**Public Comment No. 5-NFPA 72-2023 [New Section after 29.1.2]**

**Public Comment No. 199-NFPA 72-2023 [New Section after 29.1.5]****TITLE OF NEW CONTENT**

Public Comment No. 7-NFPA 72-2023 [Section No. A.29.11.3.4(4)]

Figure A.29.11.3.4(4)(d) Example of Exception Placement of Photoelectric Smoke Alarm or Smoke Detector at 72 in (1.83 m) from Stationary or Fixed Cooking Appliance.

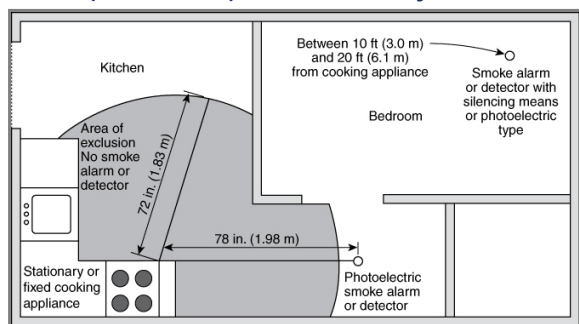
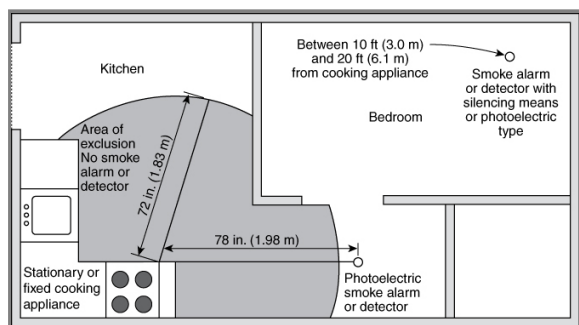
CHANGE FIGURE TO "SMOKE ALARM OR DETECTOR LISTED FOR RESISTANCE TO COMMON NUISANCE SOURCES FROM COOKING" IN BOTH LOCATIONS AND CHANGE "72 IN." TO "6 FT." AND "1.83 M" TO "1.8 M". ALSO CHANGE "78 IN." TO "6.5 FT" AND "1.98 M" TO "2.0 M"

This section required significant revisions based on changes that have been made to the body in 29.11.3.4 which basically allows only detection equipment listed for nuisance resistance to cooking to be installed between 10 and 20 feet from a cooking appliance, with a small except for these same types of nuisance-resistant detection equipment to be installed between 6 and 10 feet from a cooking appliance if 10 to 20 feet is not feasible. The rewrites change some of the figures, re-orders the section to provide a shorter introduction to the issue with nuisance alarms from legacy detection equipment followed by the discussion of nuisance-resistant equipment, and then discusses the areas of exclusion. The reference to 29.11.3.4(6) is removed. This section relates to bathrooms/showers.
